Index 102-604 Two-Lane, Two-Way, Intersection Work

COMMENTARY

LAST REVISION 11/01/21	REVISION	DESCRIPTION:	 FY 2022-23 STANDARD PLANS	TWO-LANE, TWO-WAY, INTERSECTION WORK	INDEX 102-604	SHEET 1 of 2
---------------------------	----------	--------------	--	--------------------------------------	------------------	-----------------

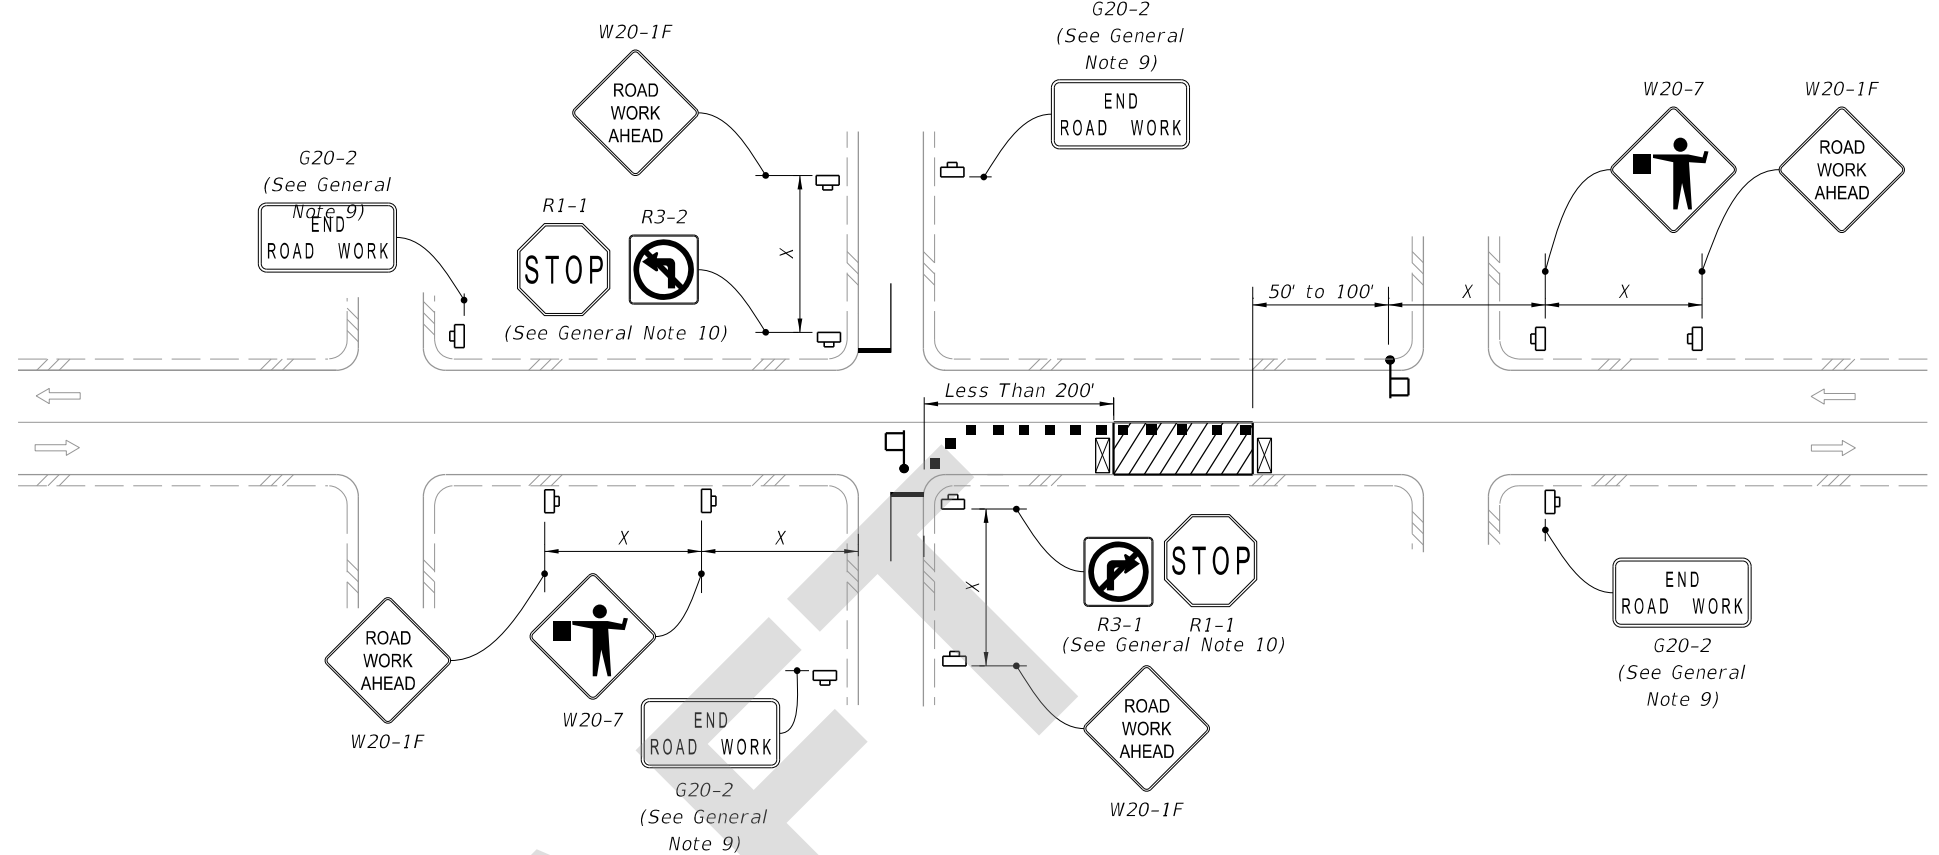
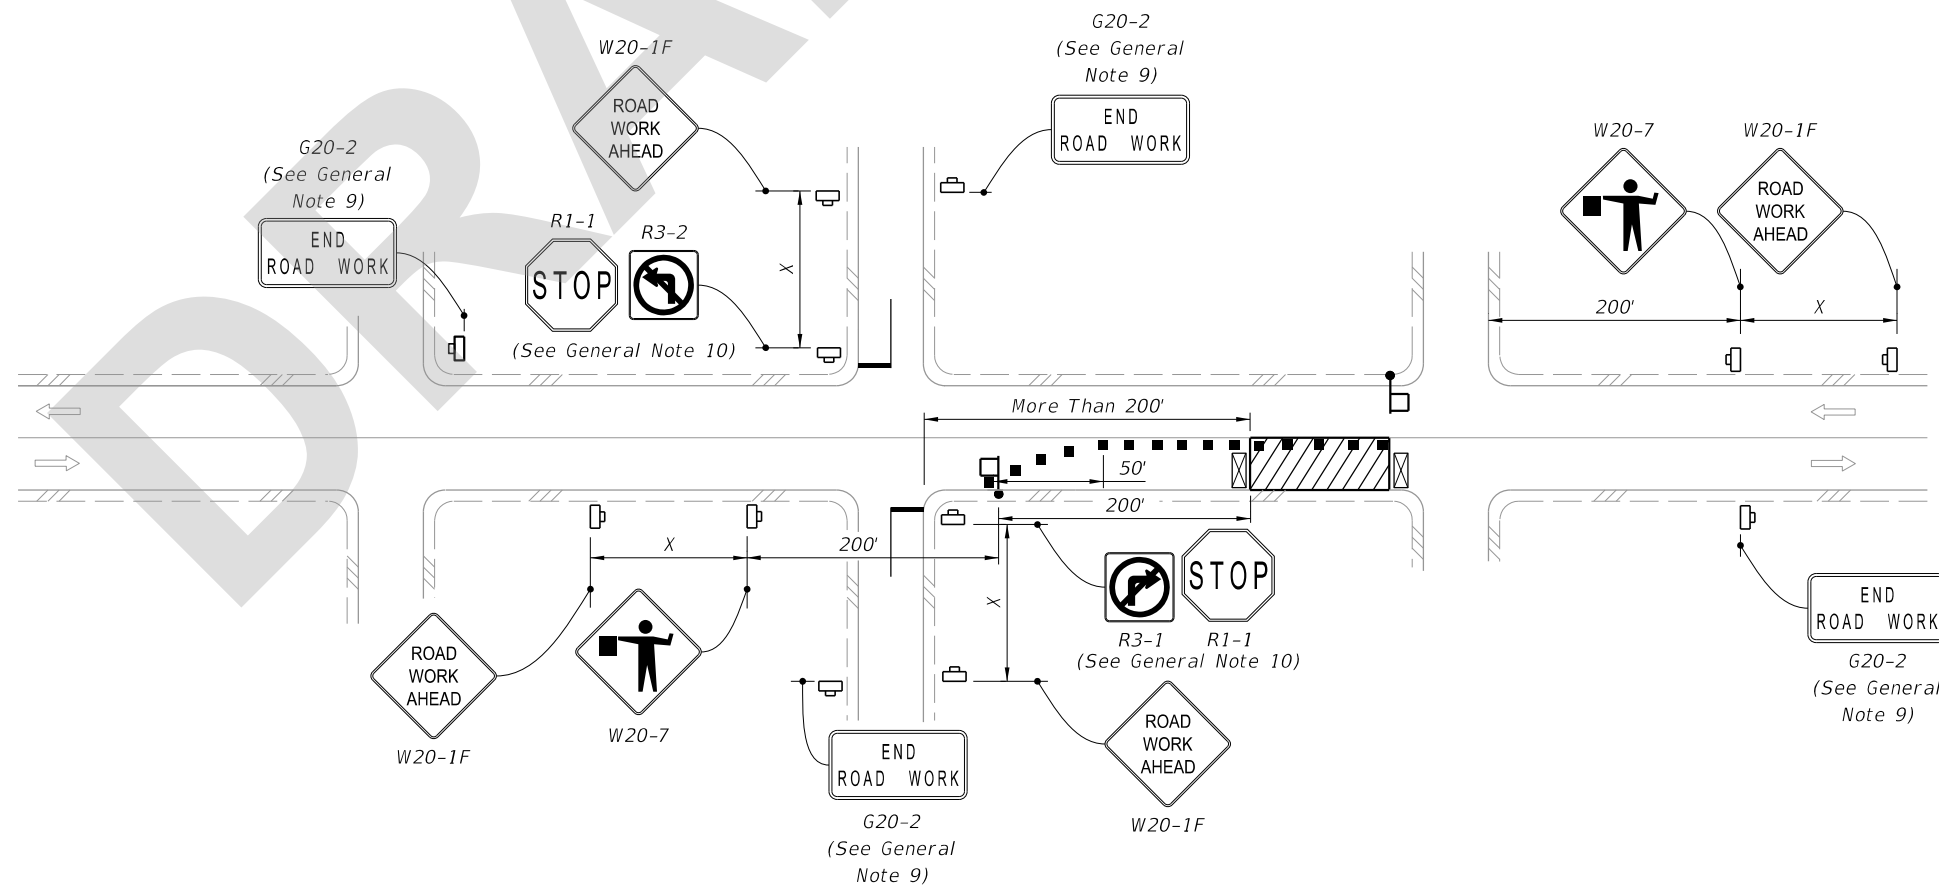
Sheet 1: Deleted Note 9; Added New General Note 9: "As an option to the "STOP" sign (R1-1) and Restricted Left/Right Turning Movement sign (R3-1 or R3-2), the "SIDE ROAD INTERSECTING THE WORK ZONE" flagging operation from Index 102-600 may be used. " Added (See General Note 9) at intersections with R1-1 and R3-2 signage.

COMMENT: Is the 4-ft paved shoulder provision intended to apply to all roadway types (i.e., limited access facilities vs. Arterials/Collectors)?

RESPONSE: No, only 4' or wider paved shoulder on non-limited access facilities are considered "Bicycle Facilities".

Change Made: Instead of revising the Note further, it has been decided to remove the redundant note from all relevant 102 Series Indexes. The FDM provides guidance on bicycle accommodations and Specification 102-3.4 will be updated to clarify the definition of a "Bicycle Facility" (i.e., existing marked Bicycle Lane or a 4' or greater paved shoulder on non-limited access roadways). **Note Deleted.**
